# Work Order ID 88789

Item Name: Crosstube Turning Detail

<b>DART AEROSPACE LTD</b>		<b>Work Order:</b>	88789
<b>Description:</b> Crosstube Assembly (412 High Aft)		<b>Part Number:</b>	D412-664-243
<b>Inspection Dwg:</b> D412-664-243 <b>Rev:</b> E		<b>Page 1 of 2</b>

NG NO. 664-243	TITLE CROSSTUBE ASSEMBLY (412 HI AFT)	REV. E	DART AEROSPACE LTD ENGINEERING ORDER		D.E.O. NO. D412-664-243-E-1	SHEET NO. SHEET 1 OF 2	SCALE NTS
	CHECKED <i>MP</i>	MFG. APPR. <i>E</i>	APPROVED <i>MP</i>	DE APPR. <i>MP</i>	DATE 11/03/31	DATE 11-03-31	
11.03.31	DATE 11/03/31	DATE 11.03.31	DATE 11/03/31

**D212-664-243**  
**ASSEMBLY DETAIL**

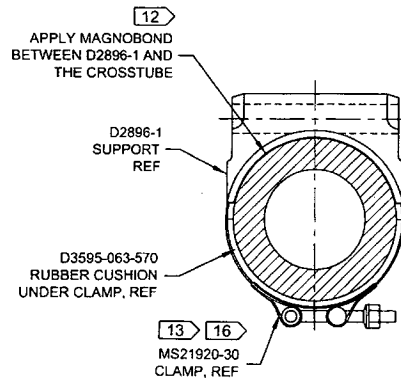
② DEO ATTACHED

**D412-664-603** 10  
**BENDING AND DRILLING DETAIL** E

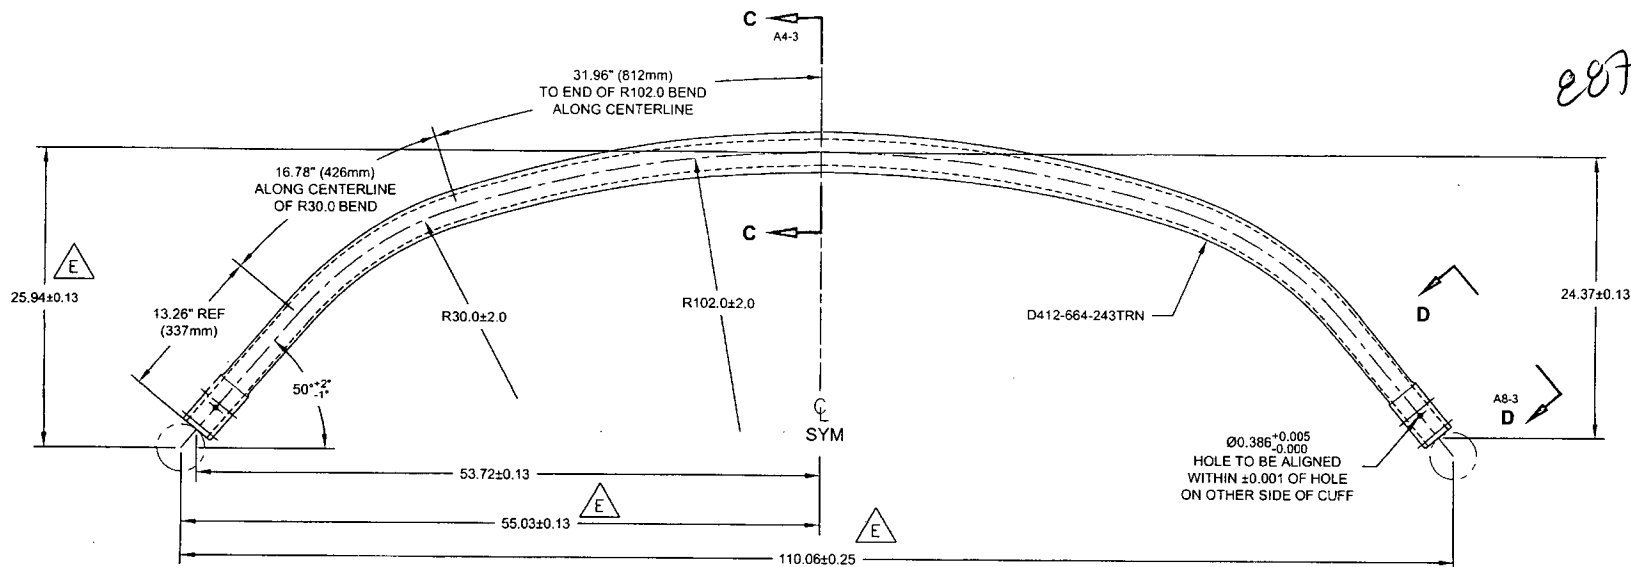
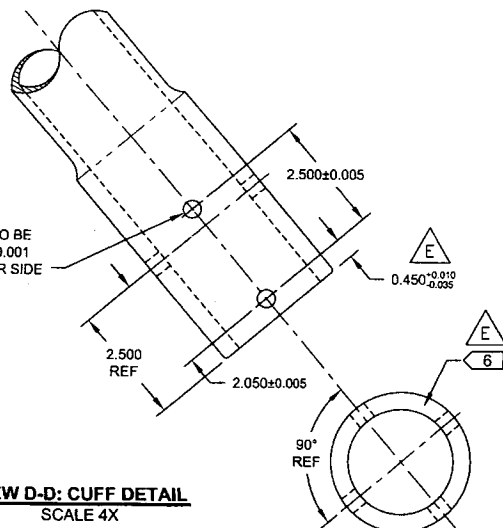
2 DEO ATTACHED
